UNITED STATES ENVIRONMENTAL PROTECTION AGENCY **REGION 8**

Re: 2018 Sanitary Survey Report

PWS ID#: WY5601439 C

2018 EPA Region 8 WY SANITARY SURVEY FORM INVENTORY

Photo #: 23

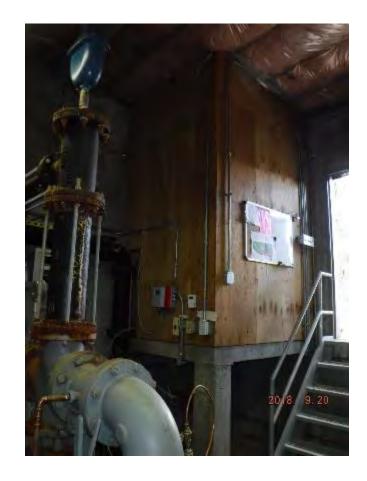
Comments: Located inside Booster

Pump (PF01) building.
